## RESPONSE TO COMMENTS

### Lapwai Regional Wastewater Treatment Plant NPDES Permit ID0028347 September 17, 2019

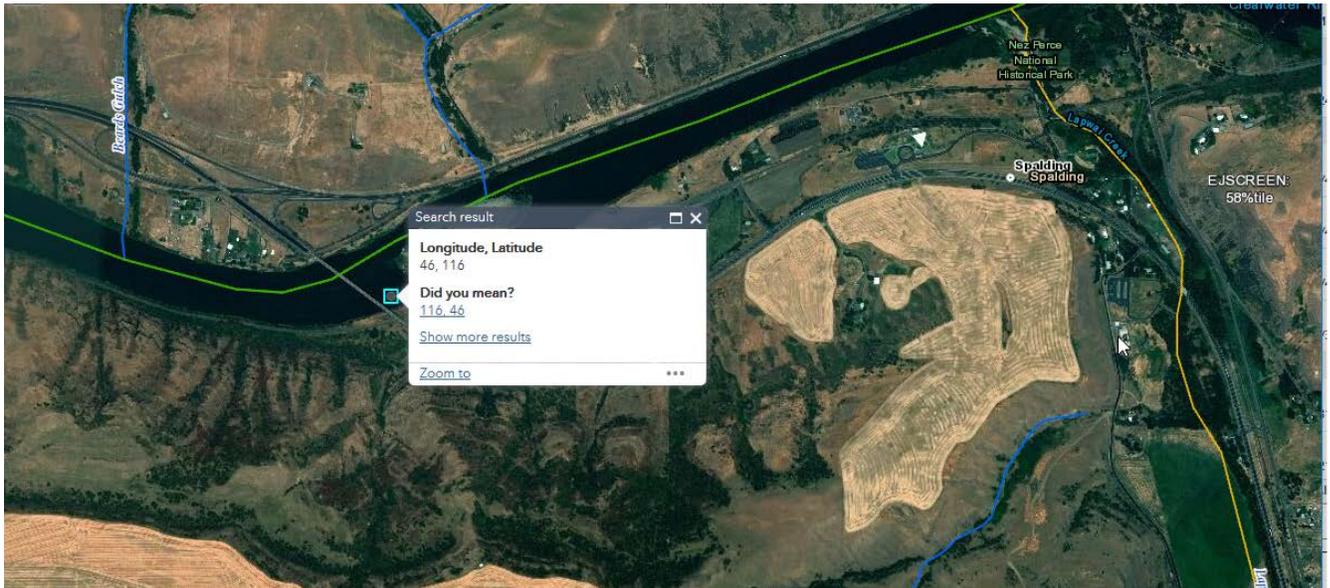
**2. Comment:** We request providing the analysis on which the Lapwai Regional WWTP ("Lapwai") Draft NPDES was based. For purposes of public noticing the draft NPDES permit, EPA provided the eight-year-old Fact Sheet for Lapwai's 2011 NPDES permit, which includes a number of fundamental errors and discrepancies. For example, at page 18 of the 2011 Fact Sheet, EPA states that the "Lapwai Valley WWTP discharges upstream from the assessment unit ID17060306CL002\_07 (the Clearwater River between the Potlatch River and Lower Granite Dam Pool)." This statement is incorrect—Lapwai, in fact, discharges directly into assessment unit ID17060306CL002\_07.

**Response:** The EPA appreciates the comment. Based on the comment the EPA reassessed the discharge location and the assessment unit of the receiving water. The review found your comment is correct and the EPA erred in stating the discharge is upstream of assessment unit ID17060306CL002\_07. Lapwai does discharge directly to the Clearwater River in assessment unit ID17060306CL002\_07.

To help clarify the location for you a map showing the outfall in the Clearwater River is shown below.
